Leaks on Glass Roof Without Roof Rail/Roof Load Carrier (M-no. 3S0): Observe Additional Procedure When Installing the Glass Roof (40/25)

Model Line: **Taycan Cross Turismo (Y1B) / Taycan Sport Turismo (Y1C)**

Model Year: **As of 2021 up to 2025**

Bodysell holes

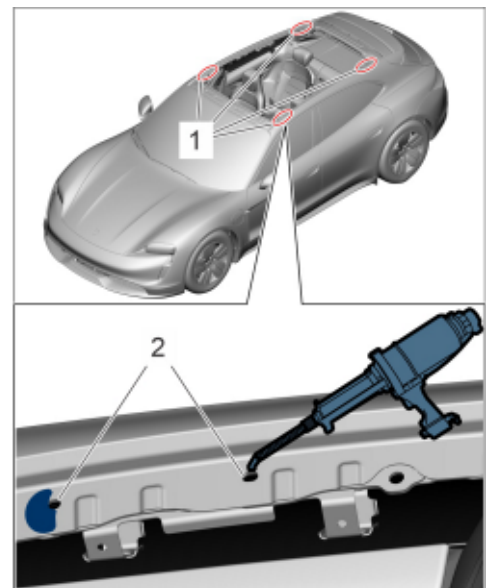
Cause: **Leaks on roof module on vehicles without roof rail/roof load carrier.**
In the Porsche Center, the leak can be limited to one or more bodysell areas, ⇒ *Bodysell holes -1-* as a result of which the roof module is removed for a new seal.

Cause: Due to too little quantity of adhesive beads or the setting behavior of Porsche 2-component windscreen adhesive, not all of the shell holes ⇒ *Bodysell holes -2-* provided for the roof rail are completely covered by the adhesive bead of the roof module.
This can result in leaks on the roof module.

Action: Before installation and **immediately before** mounting the roof module, fill all shell holes ⇒ *Bodysell holes -2-* in the shell areas ⇒ *Bodysell holes -1-* with **some** Porsche 2-component windshield adhesive.
